Public Consultation Report – Full Version

Comrie Flood Protection Scheme

Perth & Kinross Council

November 2019

Figure 3 – Revised outline design of boulevard area (including removal of pedestrian access ramp)

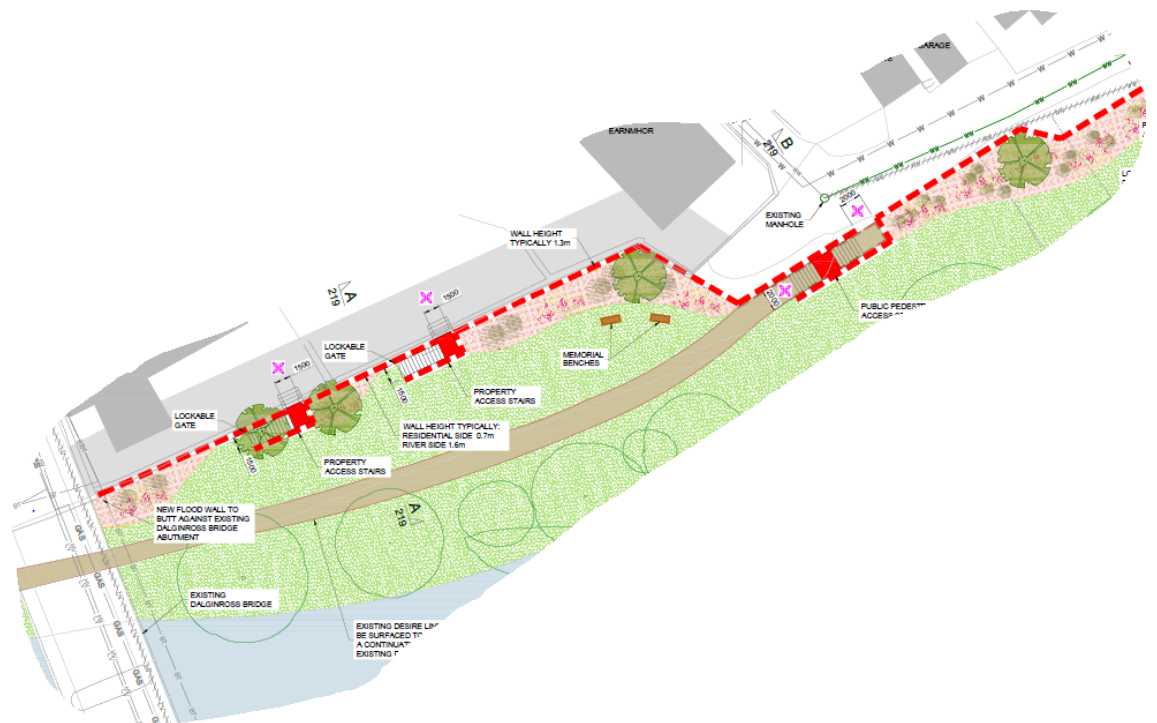
Ramps were proposed in the outline design to provide access over the flood wall. However, some consultation responses noted these were felt to be intrusive and cited a preference for flood gates in the area as an alternative.

Some respondents stated that if access ramps must be provided in this area, that there would be a strong preference to have them as hidden from view as possible or to have them located elsewhere.

Access requirements for wheelchair users were also highlighted, including the potential problems associated with unsurfaced paths.

The Council has noted from the responses received that the proposed access provision in this location was not popular with local residents. The design has therefore been amended in the boulevard area in a number of ways. The visual impact and land take have been reduced by:

1. Removing the 1:20 pedestrian access ramp that had been proposed at **Commercial Lane** and relocating it elsewhere; and
2. Removing the road access hump proposed at **Ancaster Lane**.

The removal of the pedestrian access ramp originally proposed at this location has meant that the Council has had to seek an alternative way to maintain access to the riverbank for those with mobility issues. The Council’s revised proposal is to use the existing access from Bridge Street located at the west side of Dalginross Bridge. There is already an existing ramped access here but it is too steep for some people to use in its current form. This area will therefore be altered and re-landscaped to improve access for wheelchairs, bikes and buggies to the riverbank and the boulevard area.

The proposals still include a stepped pedestrian access at the bottom of Commercial Lane but this has been relocated further away from adjacent properties to help reduce its visual impact. This will also maintain the privacy of those properties by ensuring that they won’t be overlooked by those using the steps.
